## CUSTOMER TECHNICAL MEMO # 267

**Subject** HE883 Head/Transom replaces HE831 **Date:** 25<sup>th</sup> July 2016

TOPIC  
**HE883 ProGlide / Hunter  
 Evo Head / Transom**

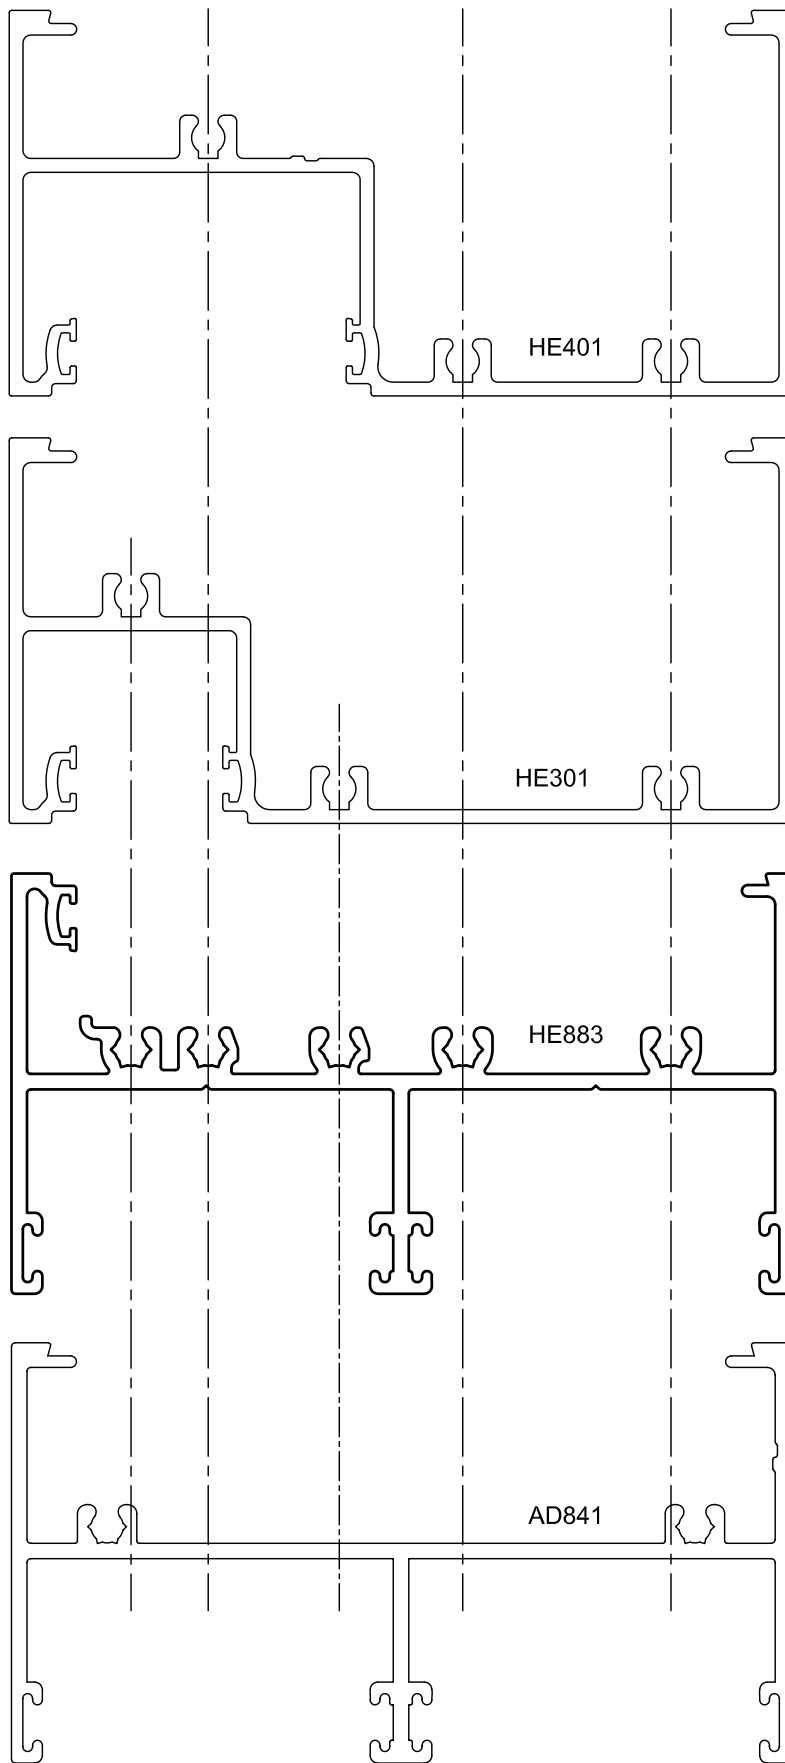
We are confirming the details of HE883 as a replacement Head / Transom section for HE831 which happened some time ago. It is a Head section when using Hunter Evo Jambes and a Transom when Hunter Evo front glazed highlights are required.

The reason for the change was to provide an extra screw flute on the head for additional support to frame and easier fabrication. HE883 uses HE332 as the single glaze adaptor and HE330 as the double glaze adaptor.

HE883 is not a mullion coupling section for Hunter Evo as the screw flutes do not align with ProGlide sections. In the case of a Hunter Evo to ProGlide jamb we recommend using HE334 or use Hunter Evo mullion with an AD750 Receiver Channel.
